VCS VALIDATION REPORT

THE MAI Ndombe REDD+ Project

REPORT N°2012-9754

Report Title	Validation Report for The Mai Ndombe REDD+ Project
DNV Ref:	PRJC-390040-2012-CCS-USA
Client	Wildlife Works and ERA Ecosystems
Pages	109
Date of Issue	6 December 2012
Prepared By	DET NORSKE VERITAS (U.S.A.). INC.
Contact	DNV Climate Change Services AS 155 Grand Avenue, Suite 500 Oakland, CA 94612 Office Phone Number: +1 510 891 0461
Approved By	Weidong Yang
Work Carried Out By	Edwin Aalders, Pablo Reed
Technical review by:	Misheck Chomba Kapambwe

Figure 1: Map showing that the PAA meets the definition of forest in 2001 (at least 10 years prior to the Project Start Date).

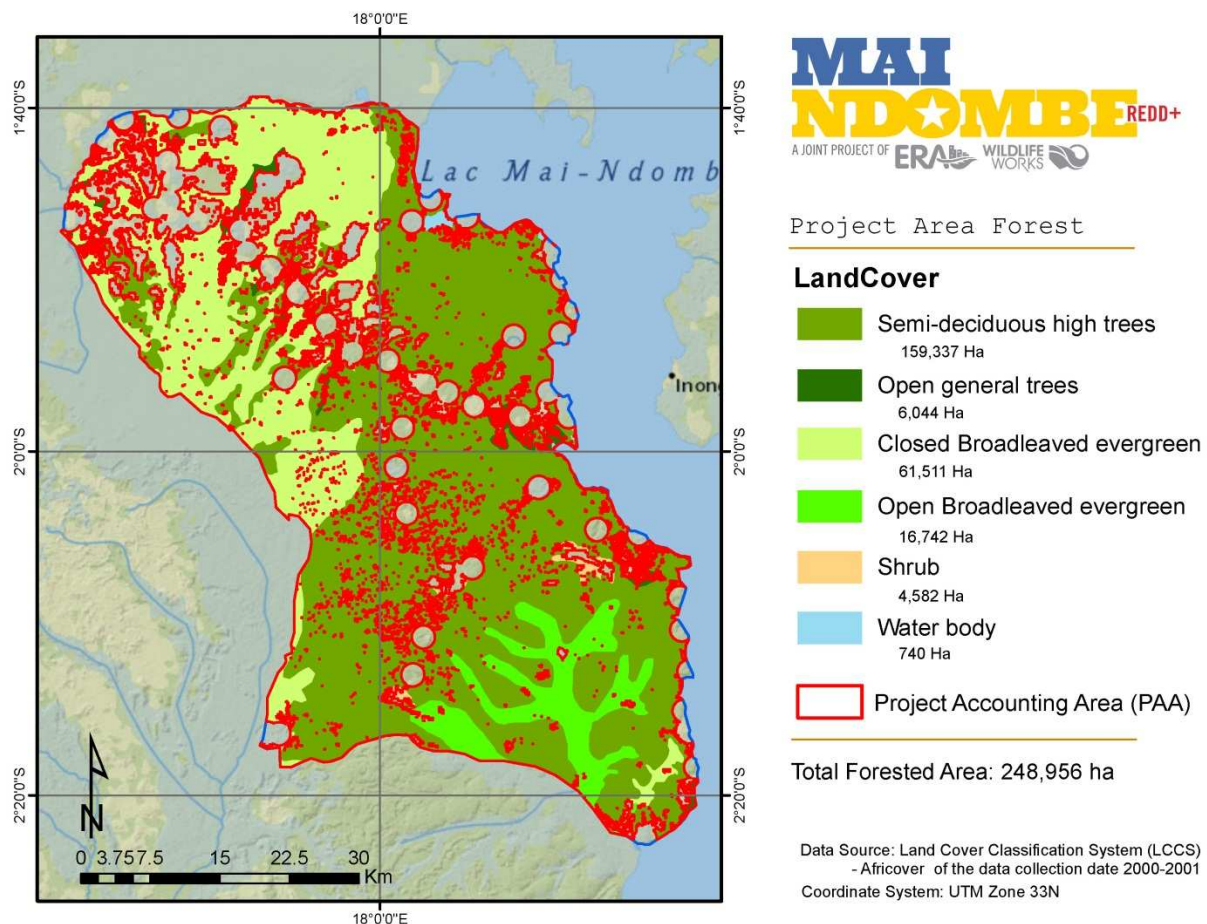
Comments on bullet point 2) above: Images of the project areas acquired in 2000 and 2001 show that the project area is considered to meet the forest definition of areas greater than 0.5 ha, trees higher than 5 meters and a canopy cover greater than 10% as defined by the FAO definition.

Areas referred to as “forêt secondaire” (secondary forest) which are described by complexes of regrowth, fallow and crops and even small villages; also known as the rural complexes dominating areas located in close proximity to villages, ports and roads with dense undergrowth and regular crown cover (Mayaux et al., 2000/51/; Devred 1958/52/), are considered non-forested, and are not included in the Project Accounting area for this project.

Figure 2: Map of soils in the Project Accounting Area indicating lack of Peat soil (Histosols).

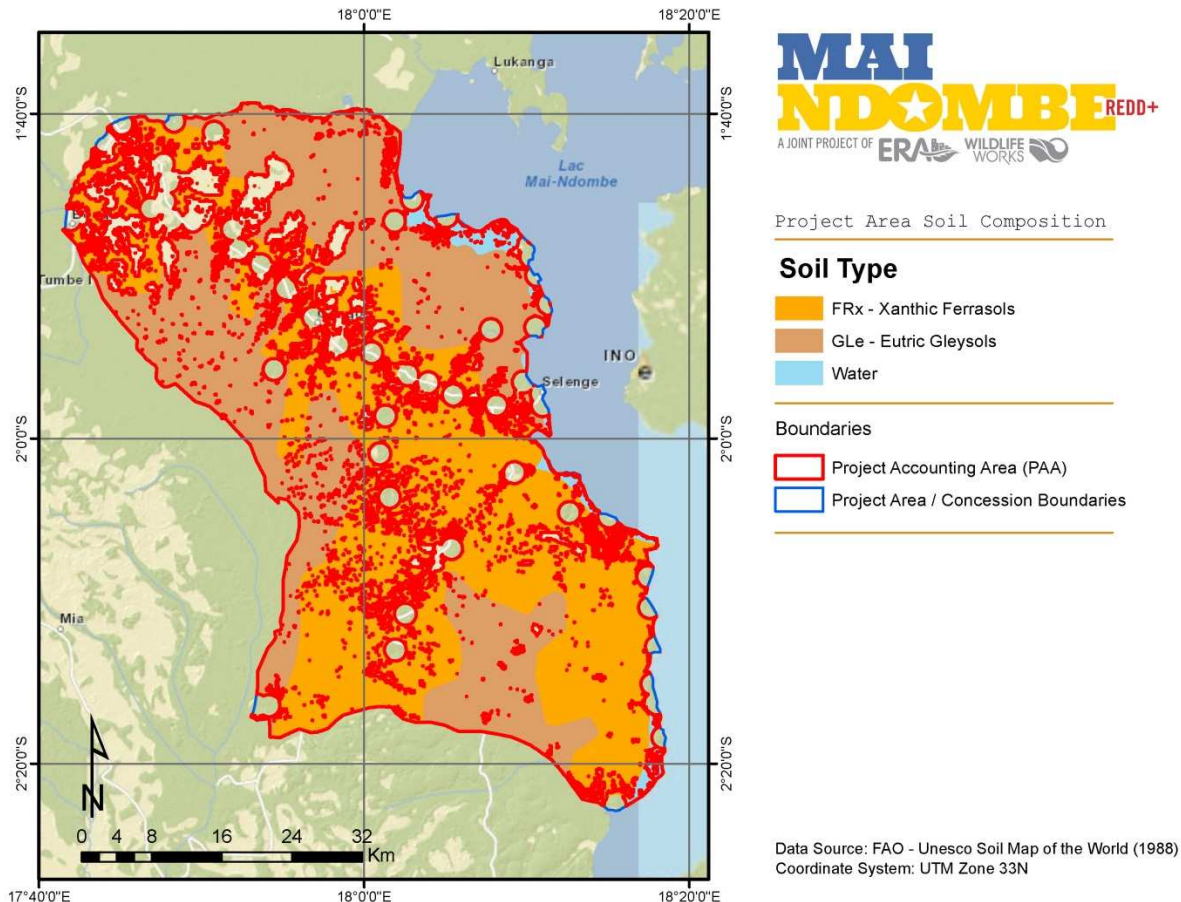
Comments on bullet point 7) above: The project has correctly identified two soil types Xanthic Ferrasols and Eutric Gleysols which are not classed as organic and/or peat soils using the FAO-UNESCO World Soil Map, Feb, 1998

Figure 1 “Figure 3 Of Methodology VM0009 version2.0”: Decision tree to determine baseline types.

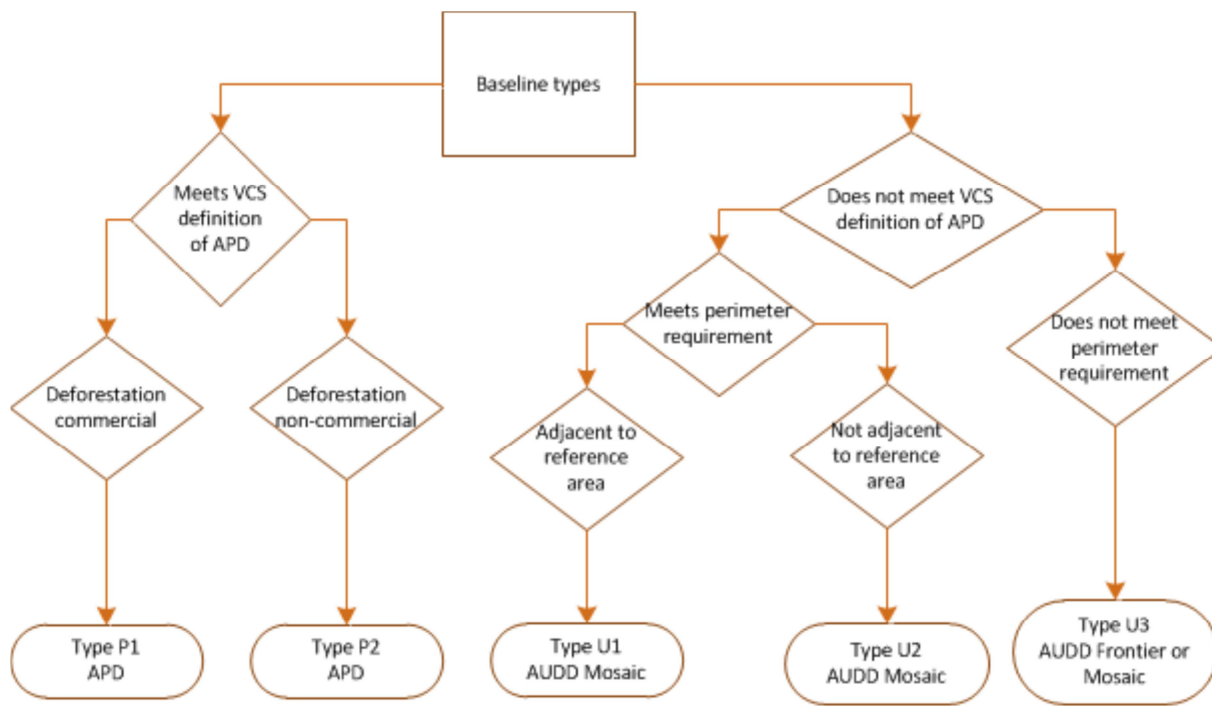
Since the project area was an eligible logging concession that was logged and could be logged again after the logging moratorium was lifted by the government, the baseline falls under the VCS definition Avoided Planned Deforestation/Degradation and as it entails commercial logging, the methodology defines that the baseline type is P1 (See Figure 1 below).

DNV confirms that the project has correctly applied the baseline identification tool of the methodology and that P1 is the baseline type valid for this project.
